ADDENDUMS / REVISIONS	
ADDENDUM NO. $\Delta$	REVISED GRADING
5/17/2013, RLS

**INDIAN RIVER INLET  
PARK ENHANCEMENTS**

**GRADES AND GEOMETRICS  
GRADING PLAN  
(BASE BID)**

UT02
SHEET NO.
169
TOTAL SHTS.
282

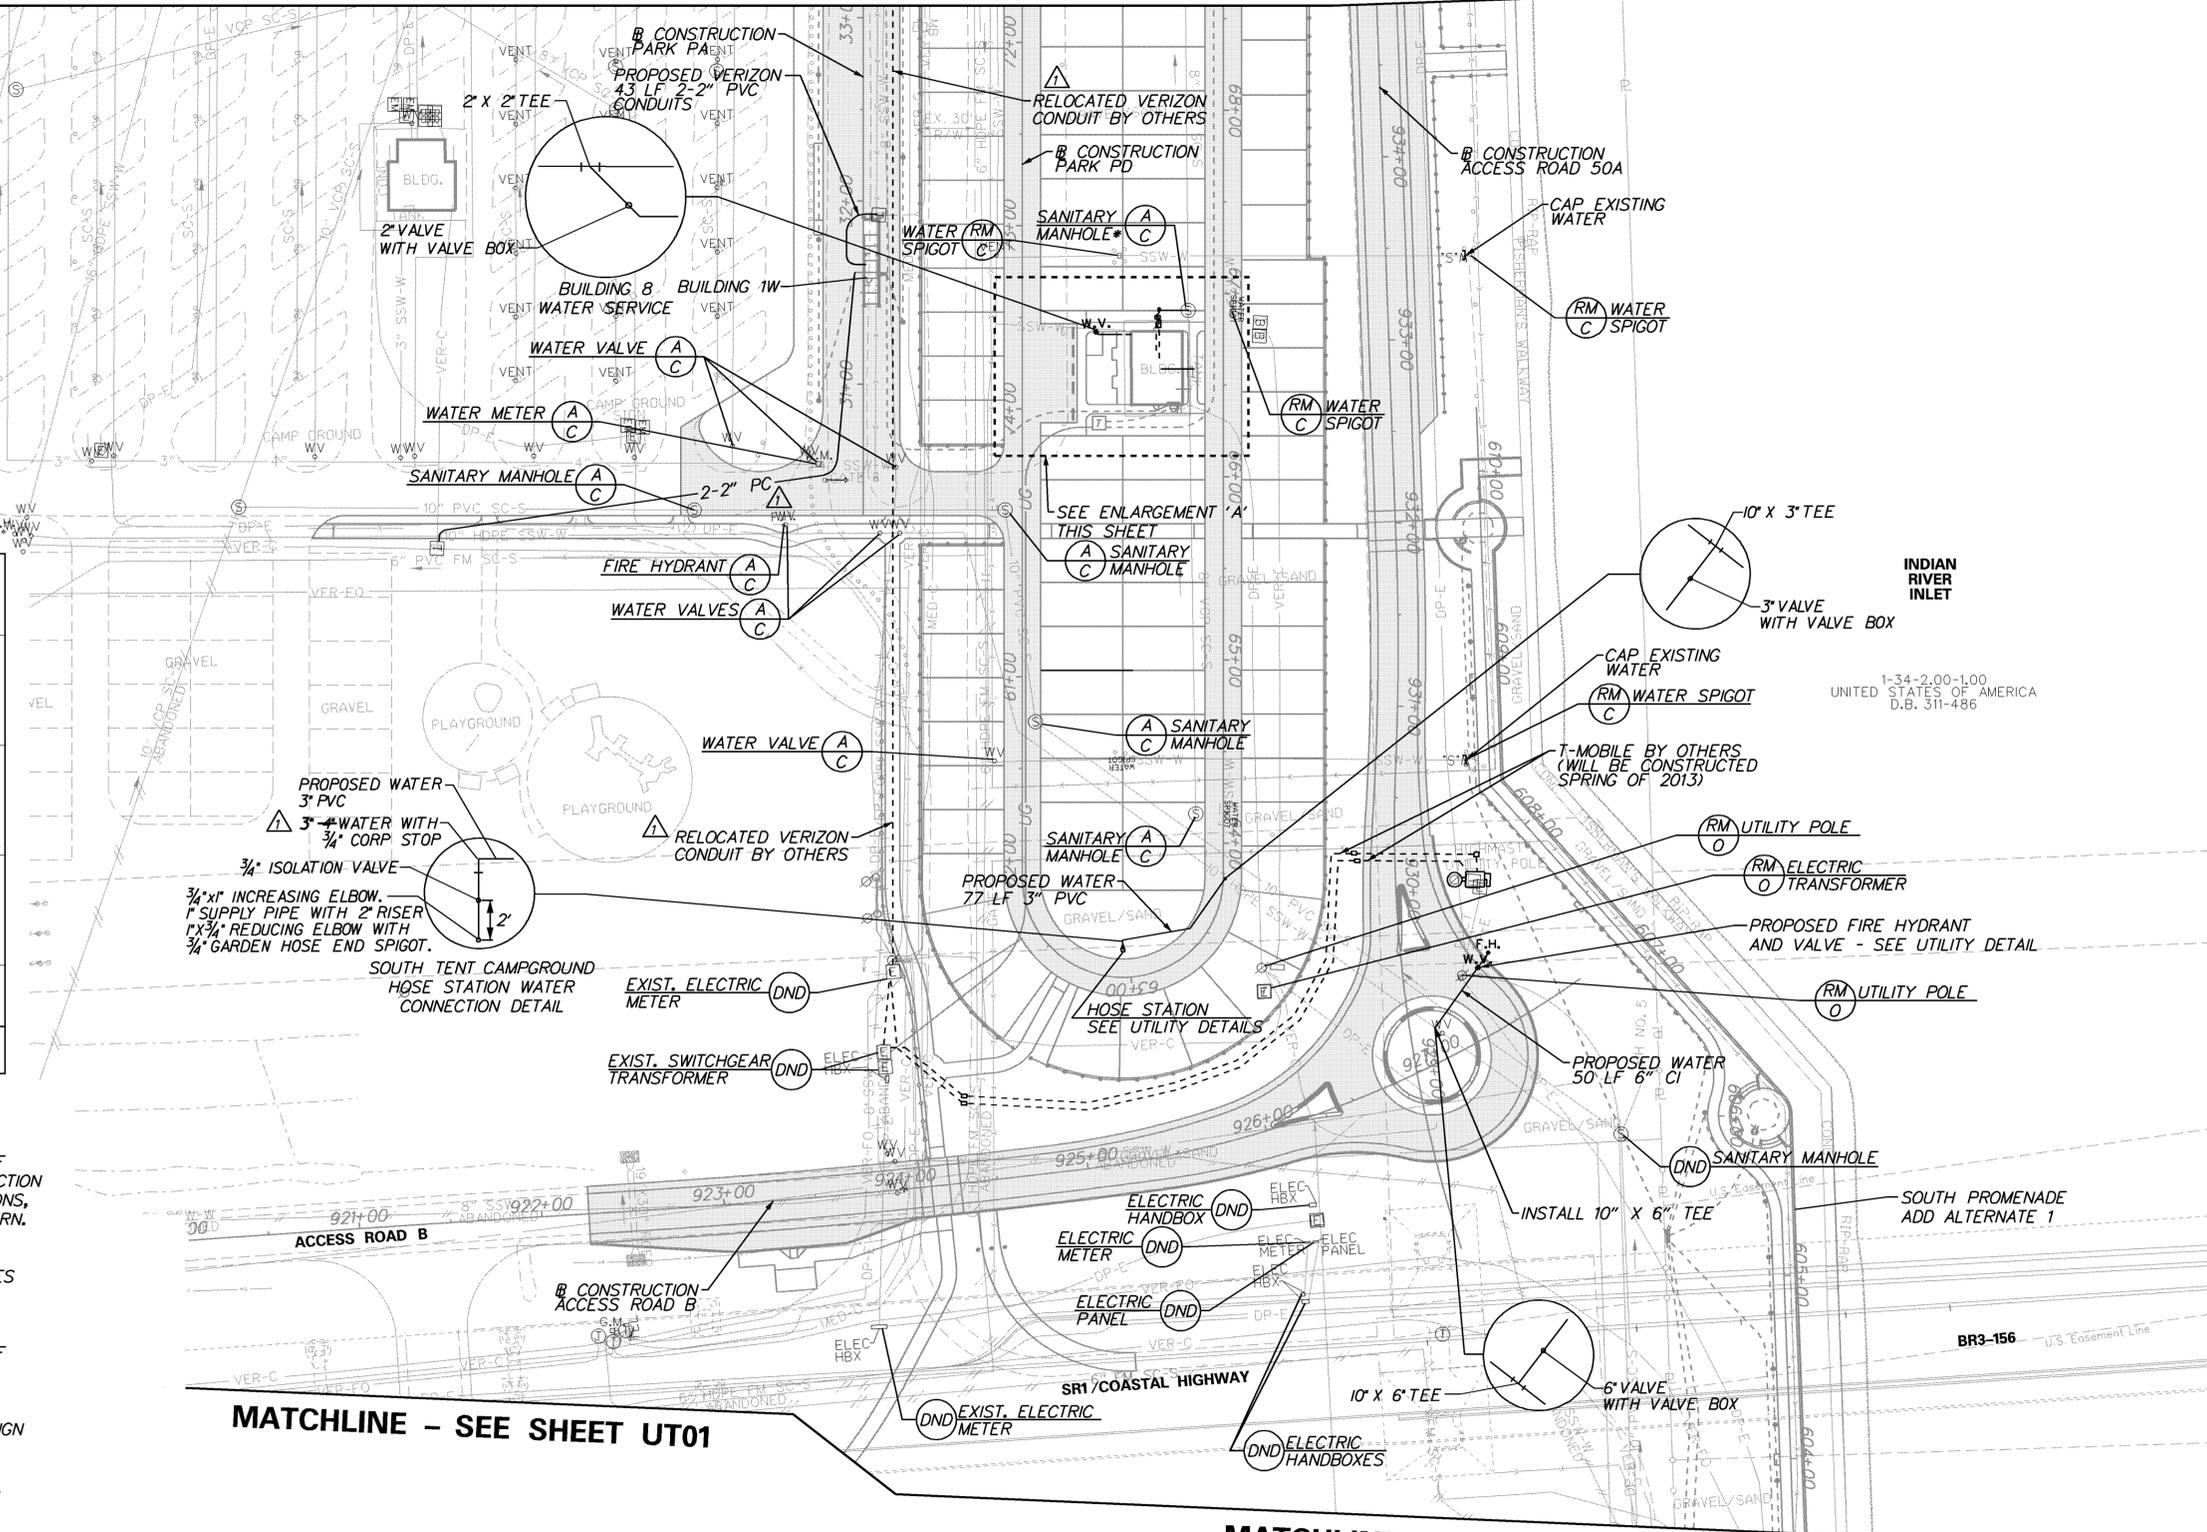
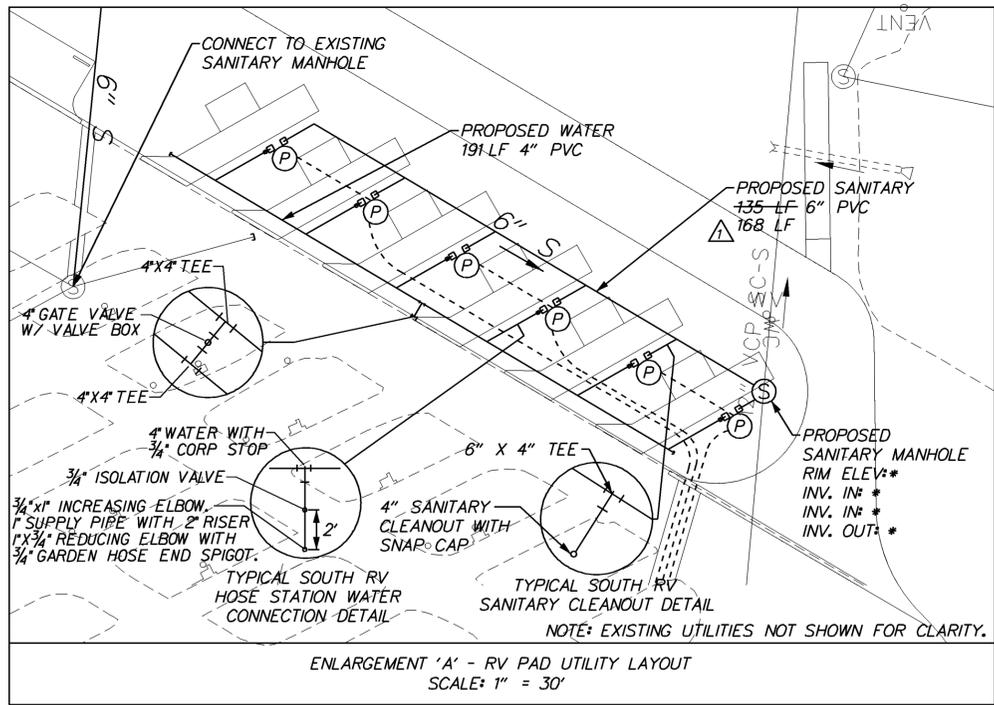
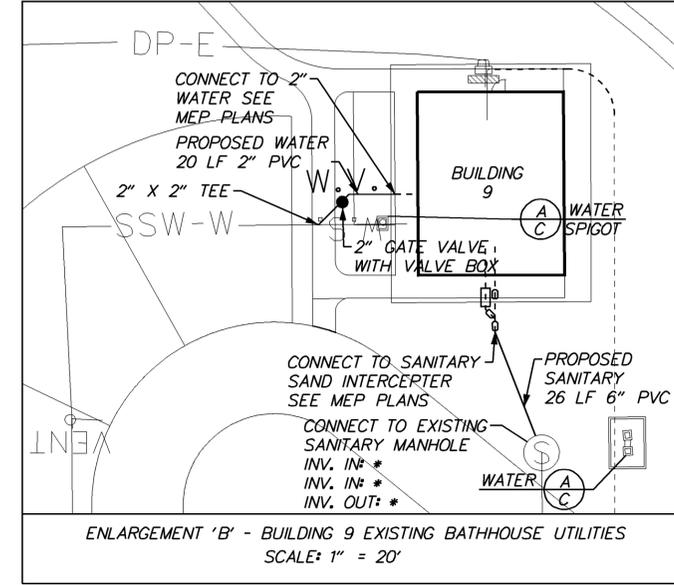
ADDENDUMS / REVISIONS	
ADDENDUM NO. $\Delta$	REVISED/ADDED NOTES
5/17/2013, RLS

\* CONTRACTOR TO FIELD VERIFY EXISTING SANITARY SYSTEM AND VERIFY THAT THE PROPOSED BUILDING SANITARY SYSTEM WILL PROVIDE POSITIVE OUTFLOW. CONTRACTOR TO SUBMIT VERIFICATION TO THE ENGINEER PRIOR TO BEGINNING CONSTRUCTION OR ORDERING ANY MATERIAL ASSOCIATED WITH THE PROPOSED SANITARY SYSTEM

<b>UT03</b>
SHEET NO.
170
TOTAL SHTS.
282

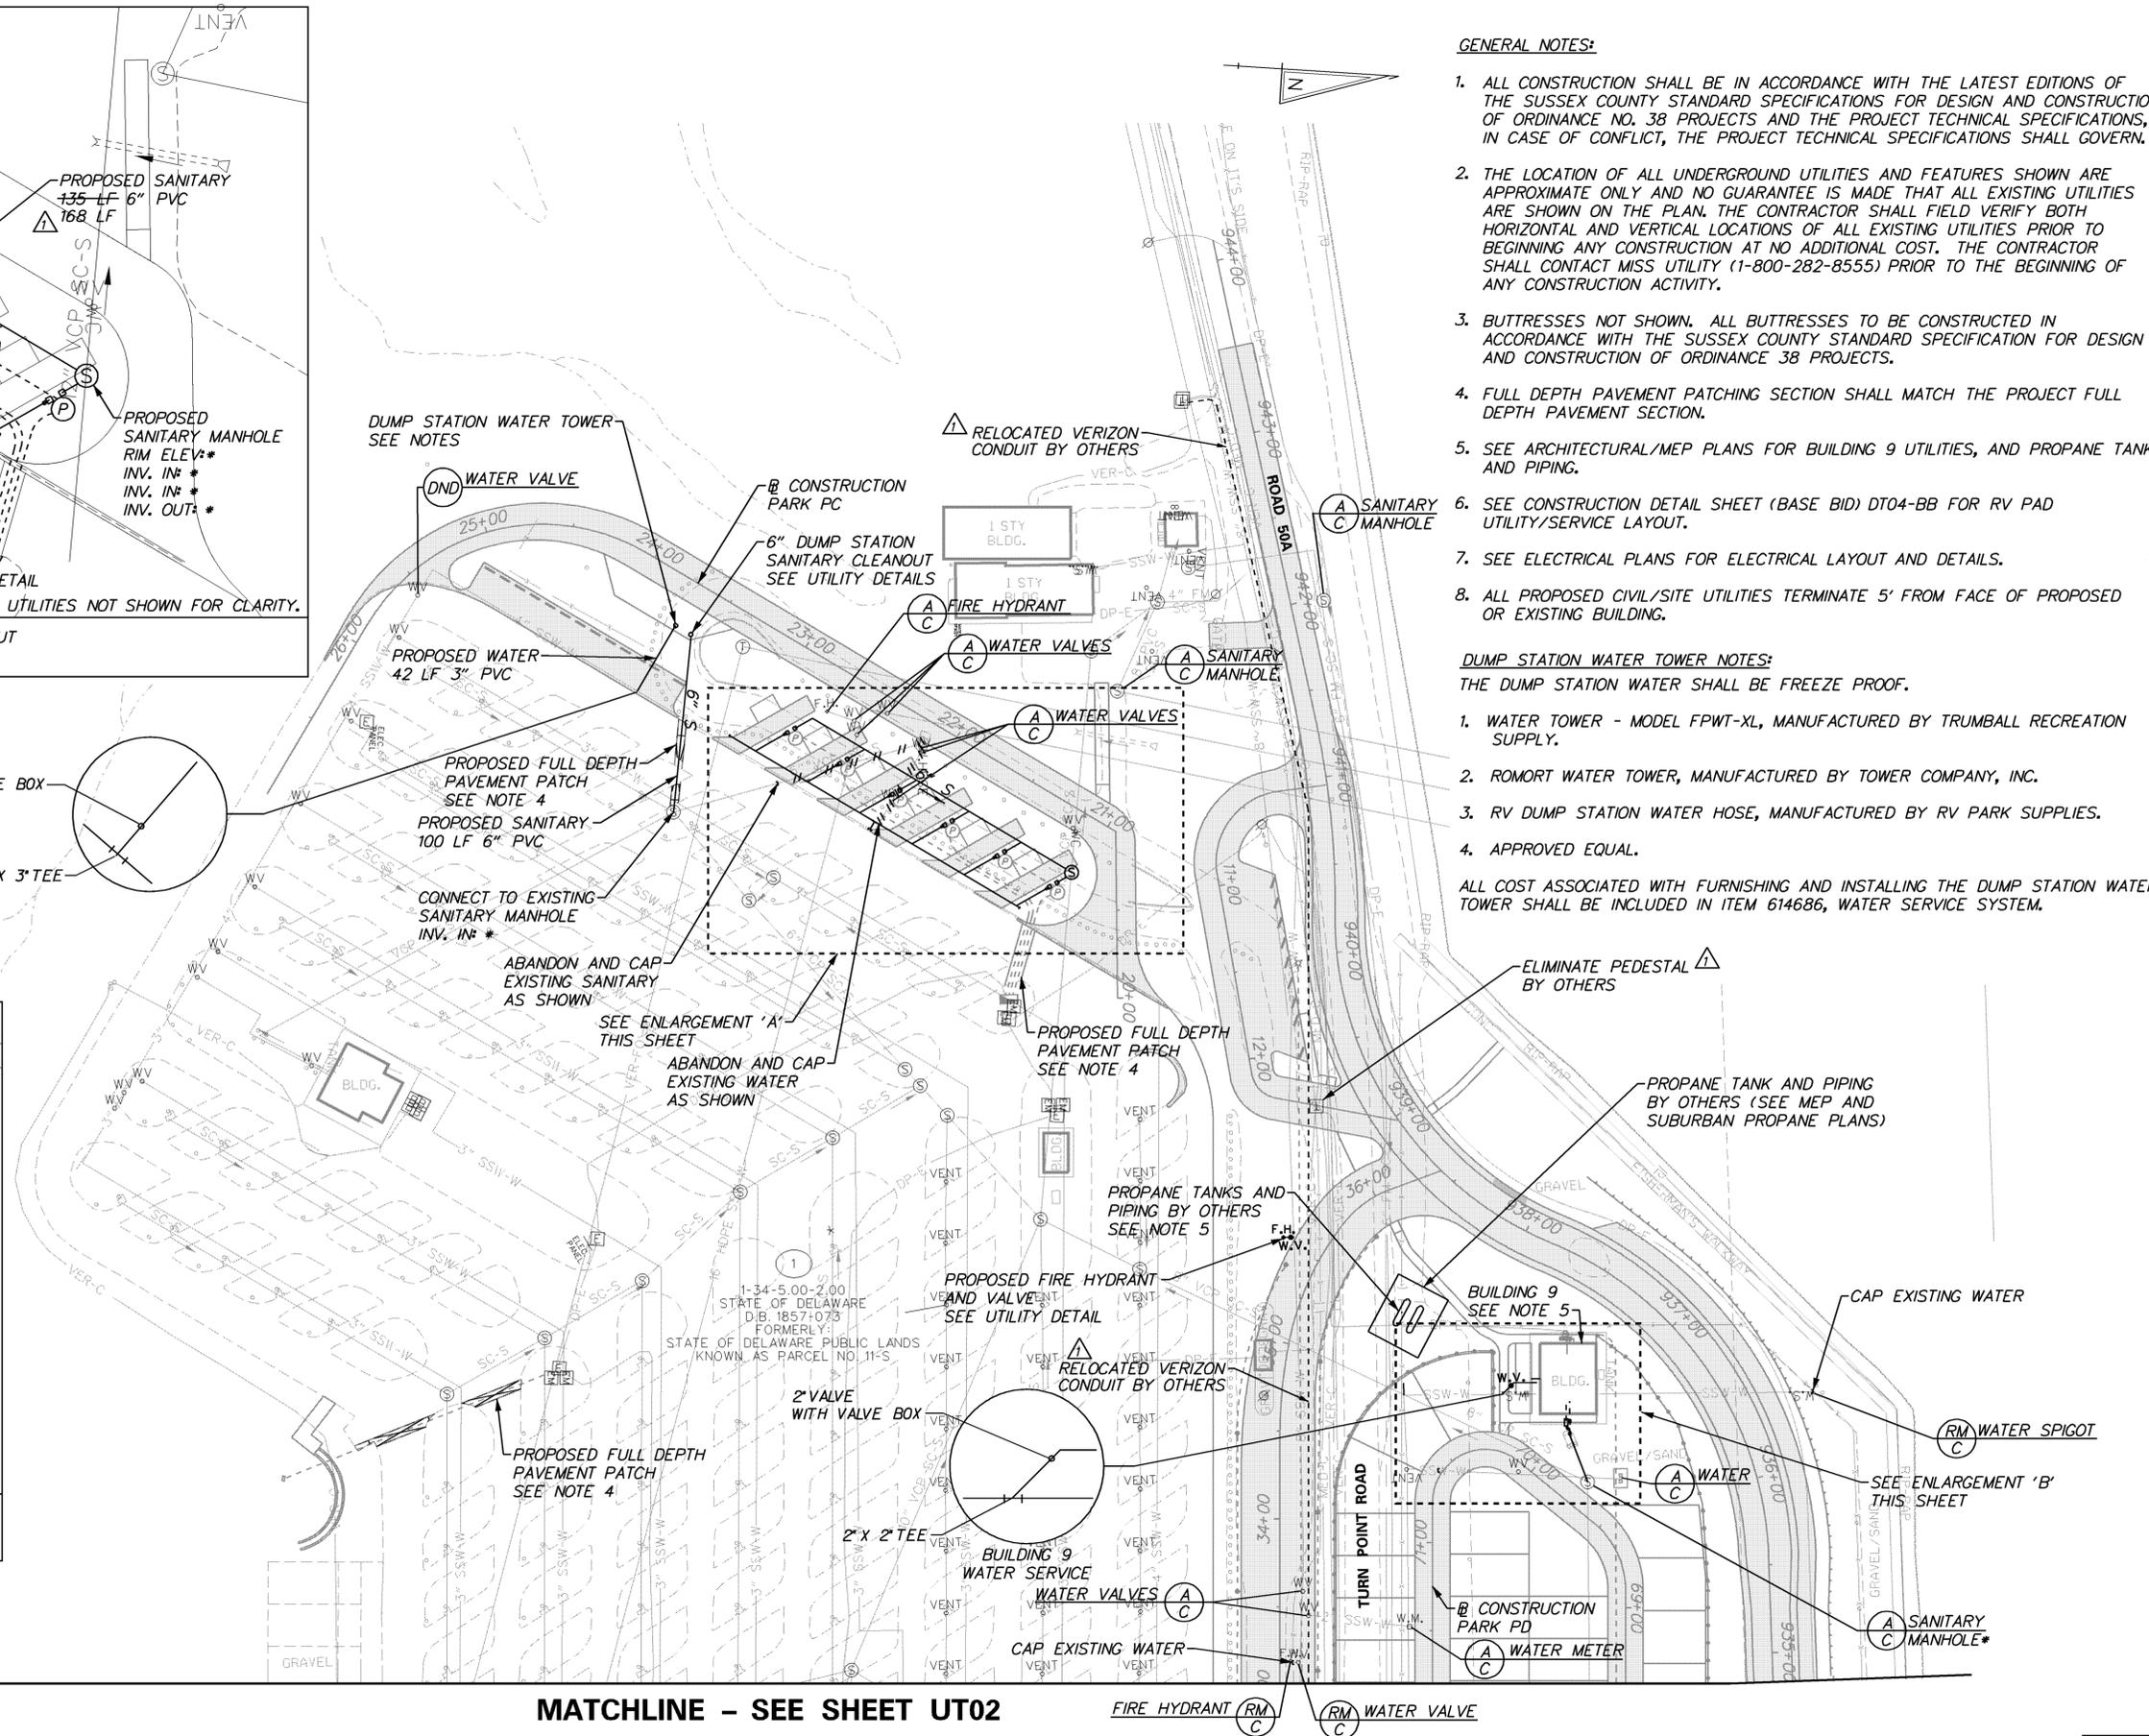
ADDENDUMS / REVISIONS	
ADDENDUM NO. $\Delta$	REVISED/ADDED NOTES
5/17/2013, RLS

\* CONTRACTOR TO FIELD VERIFY EXISTING SANITARY SYSTEM AND VERIFY THE BUILDING PROPOSED SANITARY SYSTEM WILL PROVIDE POSITIVE OUTFLOW. CONTRACTOR TO SUBMIT VERIFICATION TO THE ENGINEER PRIOR TO BEGINNING CONSTRUCTION OR ORDERING ANY MATERIAL ASSOCIATED WITH PROPOSED SANITARY SYSTEM.

6. SEE CONSTRUCTION DETAIL SHEET (BASE BID) DT04-BB FOR RV PAD UTILITY/SERVICE LAYOUT.
  7. SEE ELECTRICAL PLANS FOR ELECTRICAL LAYOUT AND DETAILS.
  8. ALL PROPOSED CIVIL/SITE UTILITIES TERMINATE 5' FROM FACE OF PROPOSED OR EXISTING BUILDING.
